# CLIO II

## 19 WHINING BETWEEN 50 AND 80 MPH (80 AND 120 KM/H)

- Engine: **F8Q 630**
- Gearbox: **JB1**

**Fig. 1**

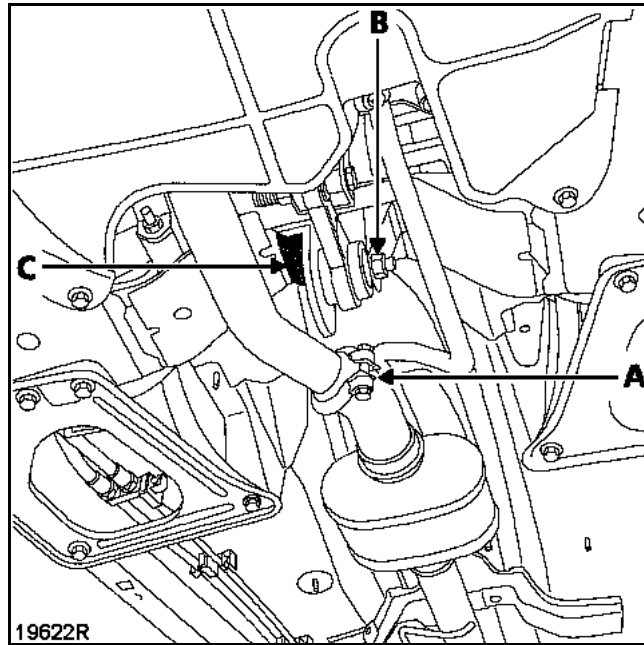
- Fitting a damper (acoustic mass) on the engine tie-bar.

- Put the vehicle on a lift.
- Release the exhaust clamp on the oxidation catcher (A) (**Fig. 1**).
- Remove the engine tie-bar mounting bolt (B) (**Fig. 1**).
- Fit the damper (C) (**Fig. 1**).
- Refit using the same procedure as for removal in reverse.
